**ACTION TRANSMITTAL No. 2014-22**

**SUBJECT:** Scope Change Request for the Crystal Lake Regional Trail in Robbinsdale  
**REQUESTED ACTION:** Three Rivers Park District requests a scope change to modify the scope of SP#091-090-075 to increase the length by 0.4 miles, change the trail alignment, eliminate three bridges, change approximately 0.5 miles of the project from off-road trail to on-street facility with shared lane markings, and move the regional trail head facilities. The change would reduce the budget to a total of \$2,600,000 with \$1,840,000 in Surface Transportation Program (STP) funds (less than the \$2,163,200 originally programmed) and an increased local amount of \$760,000.

**Subject:** Crystal Lake Regional Trail (Robbinsdale Segment)  
Additional Information for Amendment Request  
SP# 091-090-075

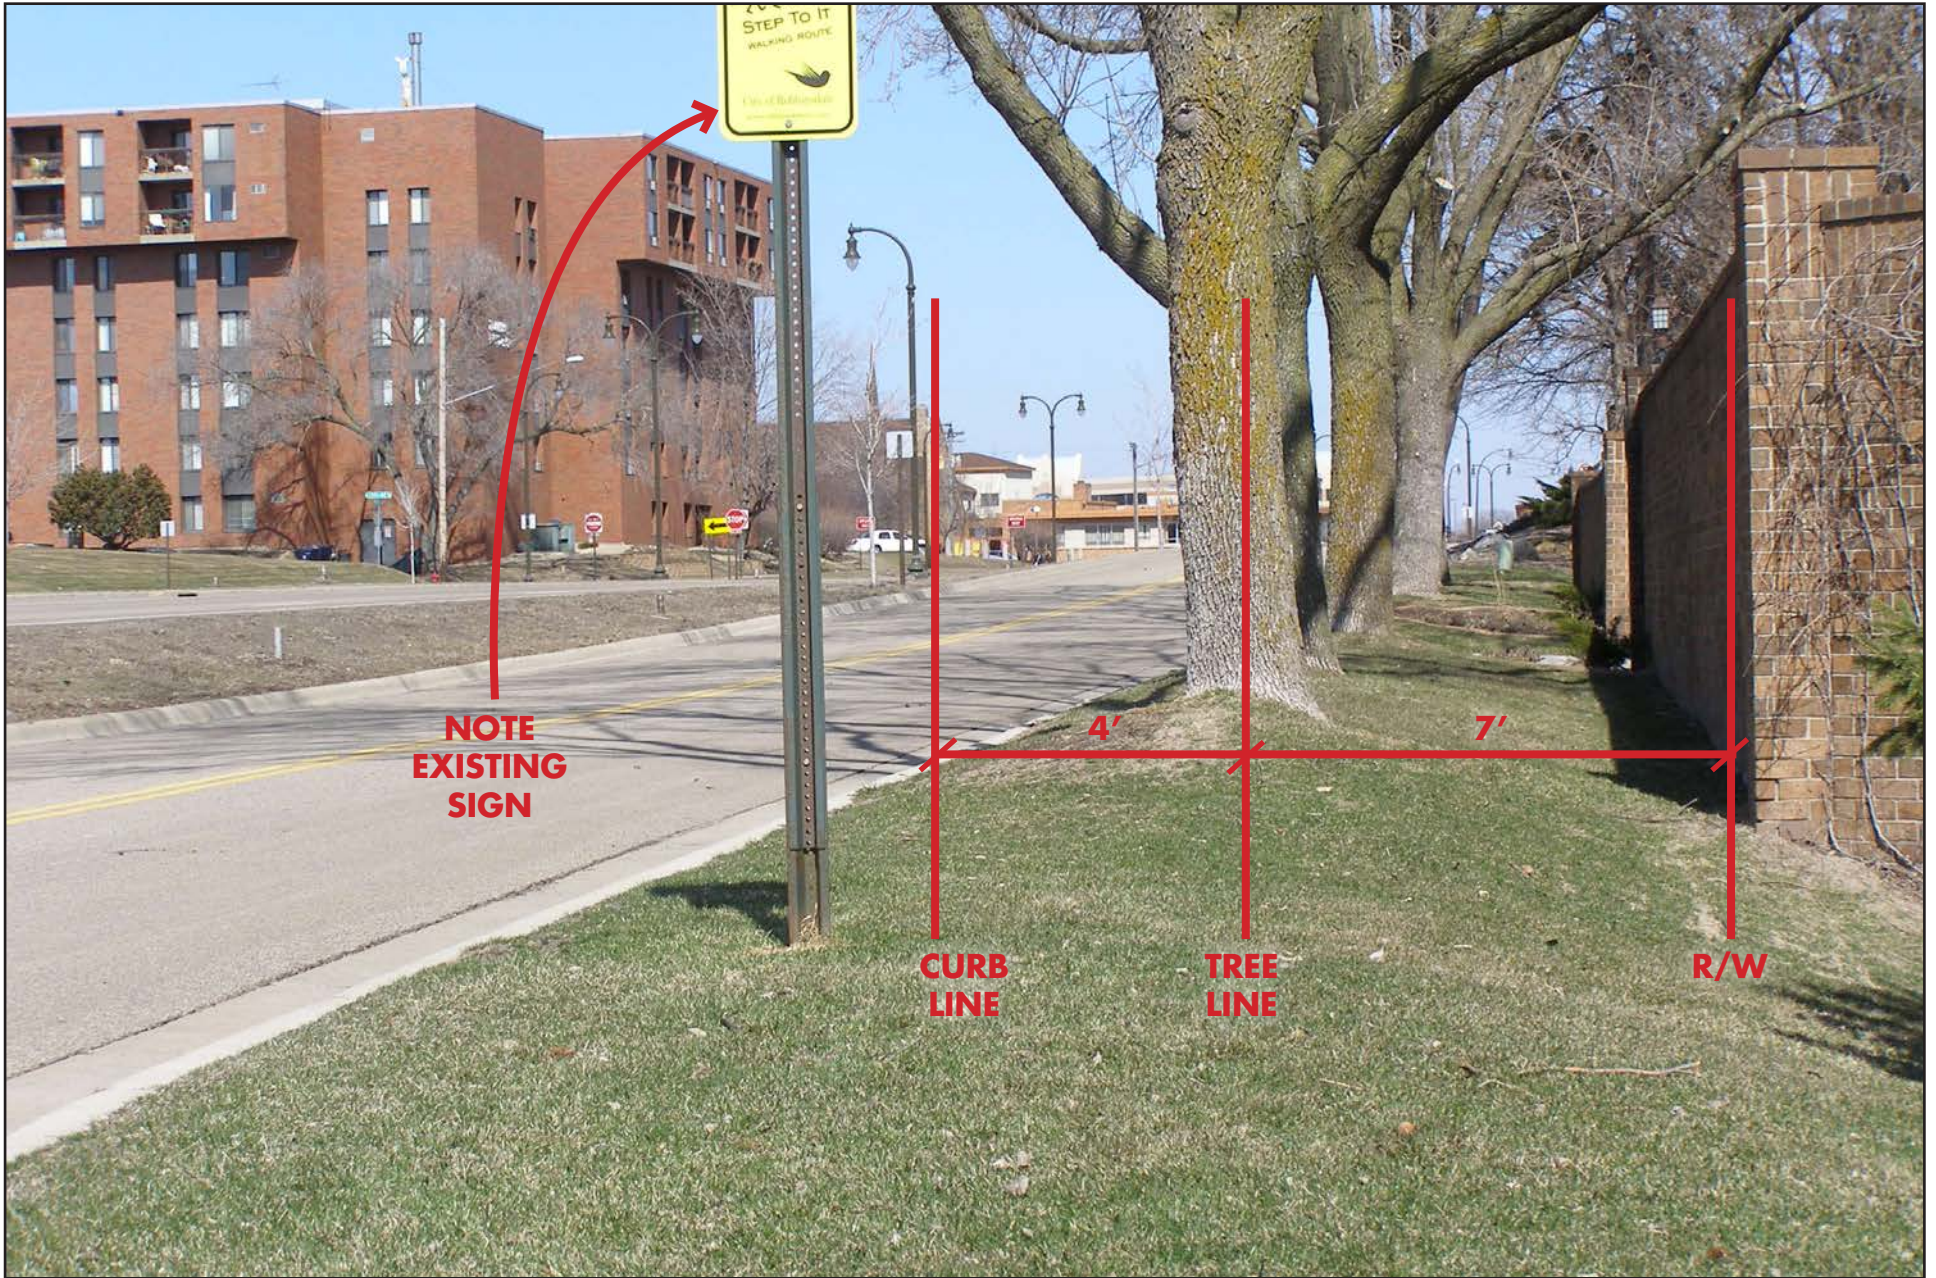
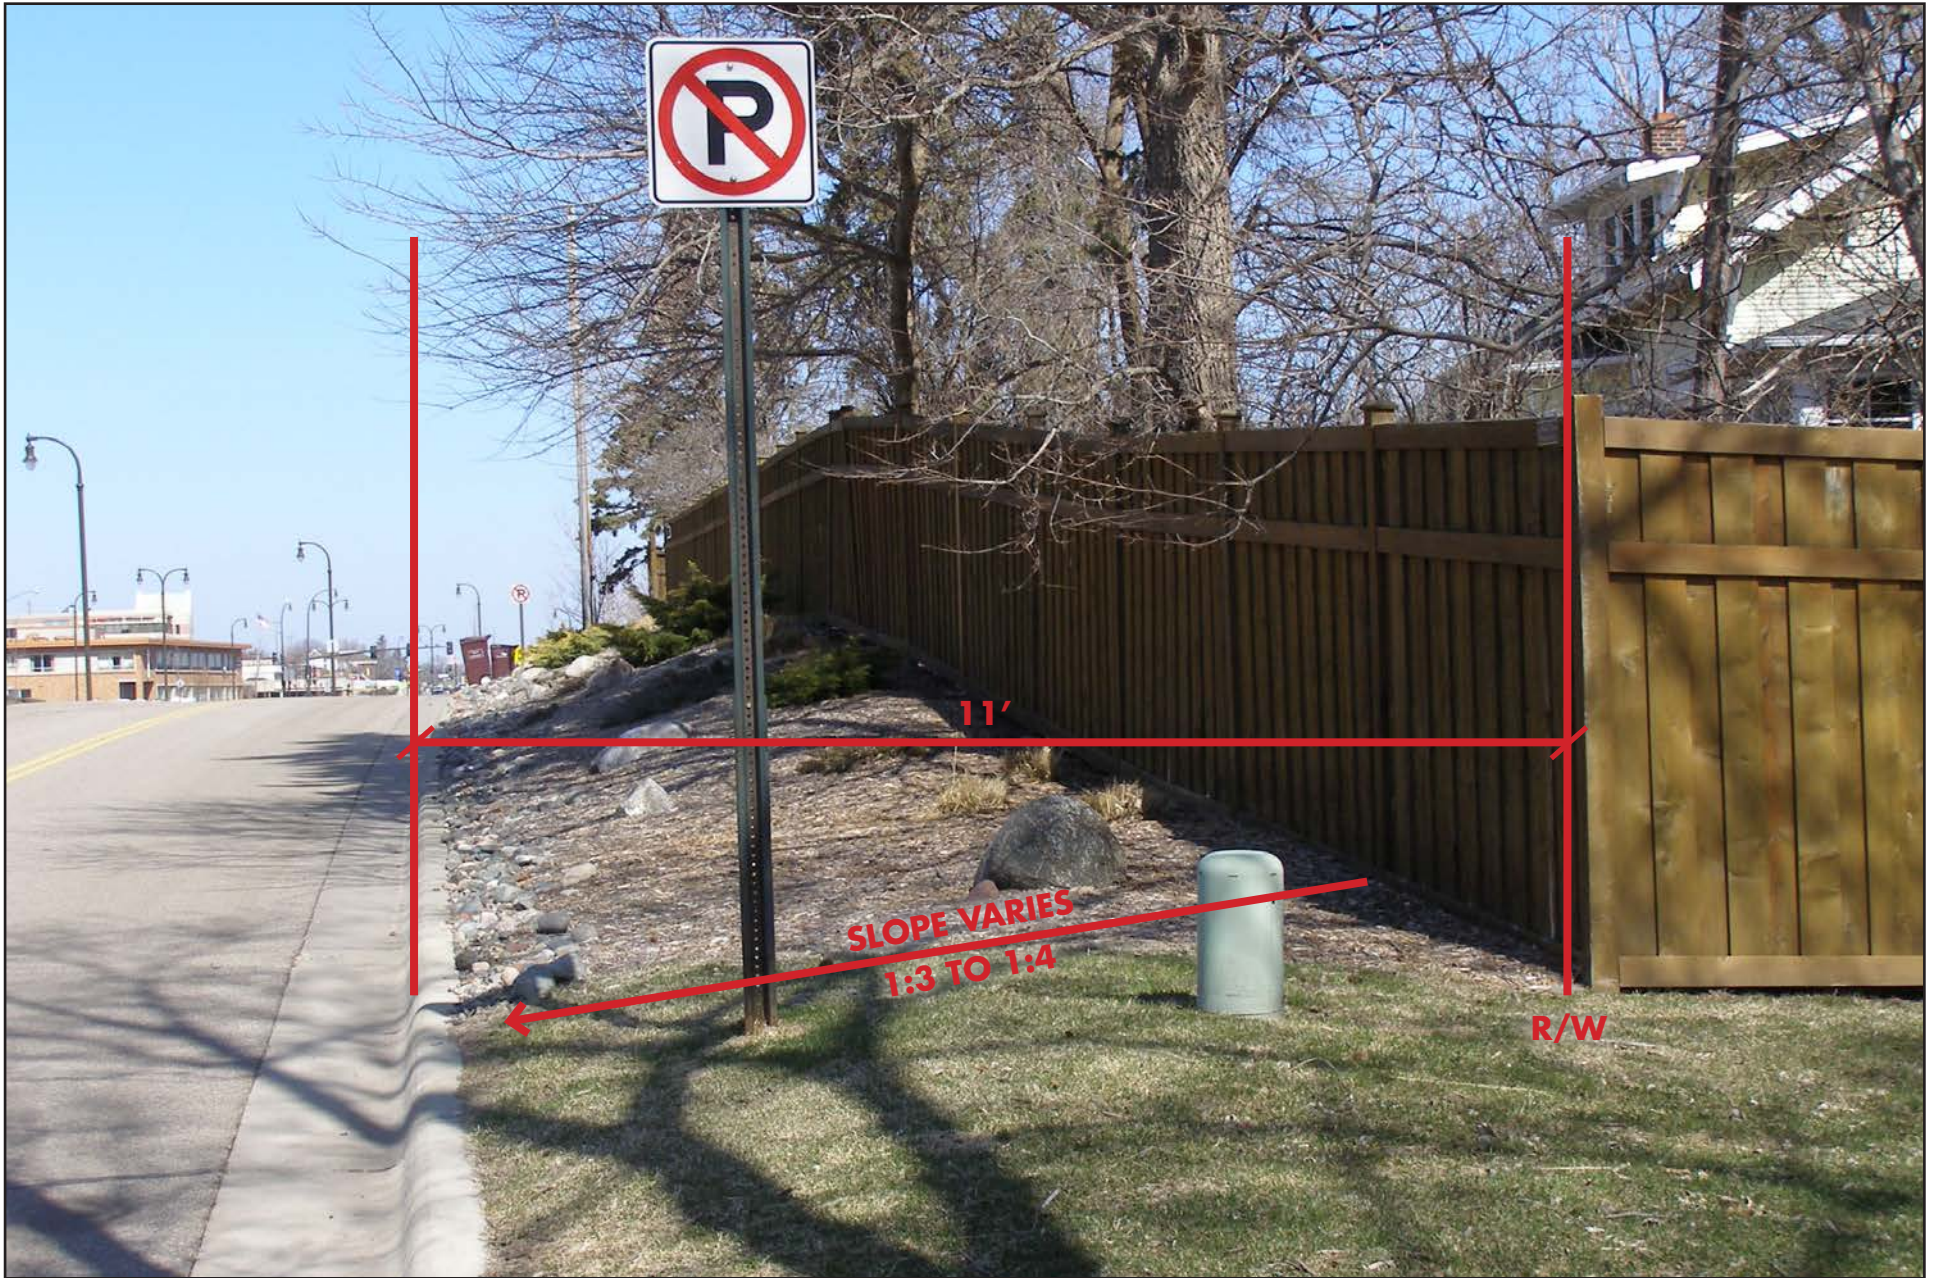
- Photographs (A, B and C) of the existing conditions adjacent to the condominium and first single family home north of the cul de sac) with key dimensions indicated on the images. All photographs are taken with a view to the north (CSAH 81 is on the left of the photos).

It should also be noted that because this is a cul de sac that serves a total of 13 residential units, it is estimated that the Average Daily Traffic (Vehicular) will be less than 100. Also note the existing sign on Photograph B (City of Robbinsdale Walking Route).

Because of the low volume of traffic, the difficulty in constructing a separated bicycle or pedestrian path/sidewalk in this area, and the existing pedestrian designation, Three Rivers Park District requests approval of the Amendment to the project scope and budget. It is our belief that the impact of constructing a separate facility for pedestrians and/or bicyclists would be significant, yet would not provide a benefit commensurate with those impacts (significant tree and landscaping removal as well as easement acquisition for construction). Additional wayfinding signs and markings will be included in the final plans for the project to provide appropriate guidance to the trail users as well as to provide awareness to those in motorized vehicles.
